# Keystone RV Company

## SAFETY ADVISORY # 18-330

### Fuzion/Impact Brake Wiring

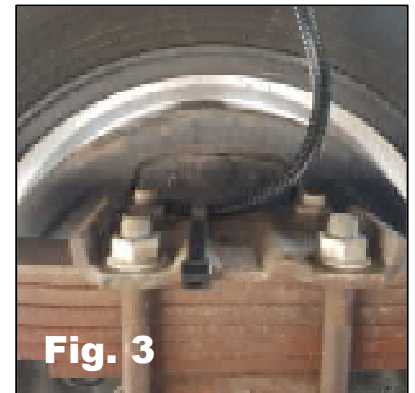
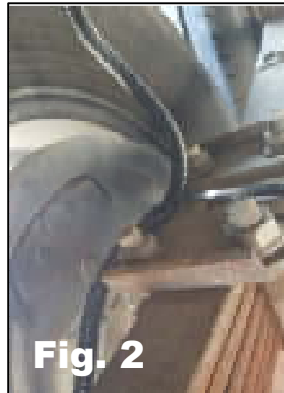
Keystone is conducting a voluntary RECALL notification campaign in accordance with the National Highway Transportation and Safety Act. It has been decided that the vehicles in the recall population have brake wiring that may touch the tires or wheels while the vehicle is in motion. Under certain conditions during travel, if the brake wires rub against the wheel or tire, there is an increased risk of property damage and poor vehicle handling.

Gain access to the brake wiring on the off-door side and inspect for damage. See Figure 1.

Add wire loom to the wires if not present and zip tie wiring to the top of the tie plate as shown in Figures 2 & 3.
